Project	IEEE 802.16 Broadband Wireless Access Working Group < http://ieee802.org/16 >	
Title	Enhanced H-ARQ MAC Support for MIMO OFDMA	
Date Submitted	2004-07-08	
Source(s)	<p>Wonil Roh, Geunhwi Lim, JeongTae Oh, Chan-Byoung Chae, Kyunbyoung Ko, Hongsil Jeong, Sung-Ryul Yun, Seungjoo Maeng, Panyuh Joo, Jaeho Jeon, Yong Chang, TaeWon Kim, Jaeyeol Kim, Soonyoung Yoon</p> <p>Samsung Electronics Co., Ltd.</p> <p>Erik Lindskog, Brett Schein, Kamlesh Rath, K. Giridhar, Aditya Agrawal, David Garrett, B. Sundar Rajan, A. Paulraj</p> <p>Beceem Communications, Inc.</p>	<p>wonil.roh@samsung.com</p> <p>Voice: +82-31-279-3868</p> <p>elindskog@beceem.com</p> <p>Voice: +1-408-387-5014</p>
Re:	Contribution supporting TGe WG ballot #14b	
Abstract	Enhanced H-ARQ MAC Support for MIMO OFDMA	
Purpose	Adoption of proposed changes into P802.16e	
	Crossed-out indicates deleted text , <u>underlined blue indicates new text change to the Standard</u> , and <u>underlined green indicates newly added text from the original contribution</u>

Enhanced H-ARQ MAC Support for MIMO OFDMA

Figure 1 H-ARQ region allocation

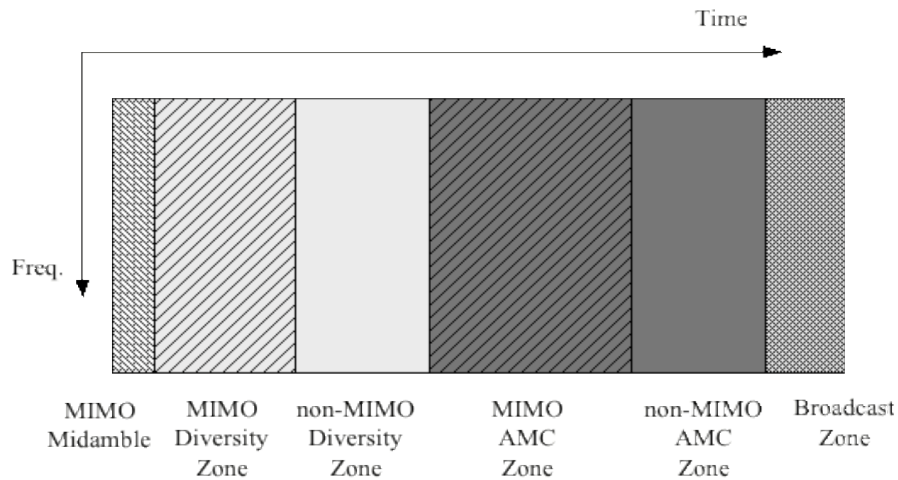
2.5 MIMO Region Compact DL MAP IE

Figure 1 shows the region allocation when using H-ARQ MAP messages in the frame.

Inside the H-ARQ region which is defined by Format Configuration IE, the allocation of MIMO region shall be represented by MIMO Region Compact DL-MAP IE in Table 99c. In order to help channel estimation and tracking a The MIMO midamble is placed at the very first symbol in the region defined by H-ARQ Format Configuration IE if either of the fields “Number Symbols for MIMO Diversity” or “Number Symbols for MIMO AMC Region” are non-zero.

Syntax	Size	Notes
MIMO Region Compact_DL-MAP_IE () {	-	-
_DL-MAP Type	3 bits	Type = 7
_DL-MAP Sub-Type	5 bits	MIMO Region = 0x03
_Length	4 bits	Length of the IE in Bytes
_Number Symbols for MIMO Diversity Region	46 bits	MIMO diversity region is placed before the normal diversity region
_Number Symbols for MIMO AMC Region	46 bits	MIMO AMC region is placed before the normal AMC region
}	-	-
